ARKANSAS
SCHOOL
FOR MATH,
SCIENCES,
+ THE ARTS

ADDENDUM #6

SUBJECT: ASMSA FB-25-005

ALTERNATES

TYP. ASPHALT PAVING SECTION
N.T.S.

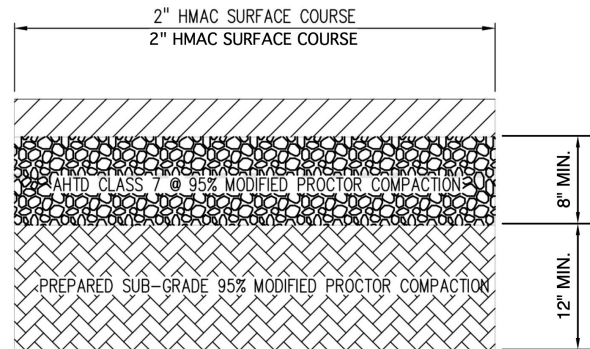
A. ALTERNATE NO. 1:

REPLACE the concrete parking lot with asphalt.

Replace the concrete parking lot with an asphalt system, installed per the detail indicated here. See Sheet C100:

State on your Bid Form the amount to DEDUCT from the Base Bid if this alternate is accepted.
